MIL-T-17442B(SHIPS)
AMENDMENT - 1
31 May 1968

MILITARY SPECIFICATION

TENSIOMETERS, DIAL INDICATING, HYDRAULIC, REMOTE READING AND MAINTENANCE KIT (MINESWEEPING)

This amendment forms a part of Military Specification MIL-T-17442B(SHIPS), 11 May 1964.

Figure 5 - Cylinder Assembly

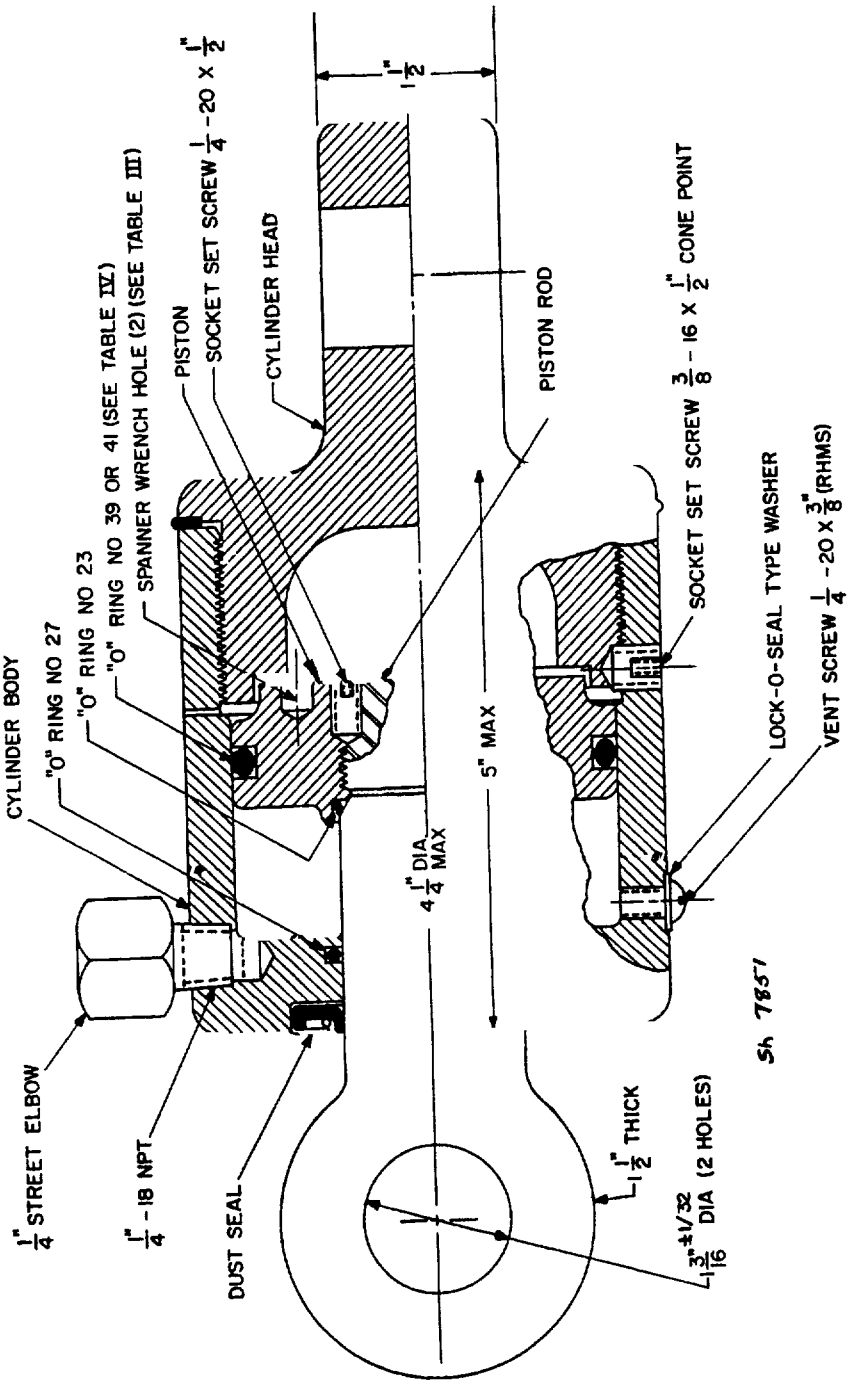
Figure 5. Delete and substitute attached Figure 5.

"3.7.1 Repair parts.

Quantity	Description
1/ 8 each	"O" ring Nos. 23, 27, 39, 41
8 each	"O" ring No. 6 (for gage)
1 each	1/4-inch pipe coupling, 1/4 x 1/8-inch pipe bushing and 1/8-inch pipe nipple 5 inches long.
2 each	Hose coupling, 3/16 inch, with 1/4-inch NPT (opposite end grooved for spring).
2 each	Hose coupling, 1/4 inch, with 1/4-inch NPT (opposite end grooved for spring).
2 each	Spring for 3/16-inch hose.
2 each	Spring for 1/4-inch hose
1/ 4 each	Dust seal (piston), National Seal No. 40059, or equivalent.
1/ 2 each	Vent screw 1/4-20 x 3/8 inch RHMS (brass).
2 each	Vent screw 5/16-18 x 3/8 inch RHMS (brass).
1/ 2 each	Socket set screw, 3/8-16 x 1/2 inch, cone point (CRES).
2 each	Socket set screw, 5/16-18 x 1/2 inch, cut point (CRES)
1/ 8 each	Lock-O-Seal type washer for 1/4-inch vent screw.
8 each	Lock-O-Seal type washer for 5/16-inch vent screw

1/ See figure 5. "
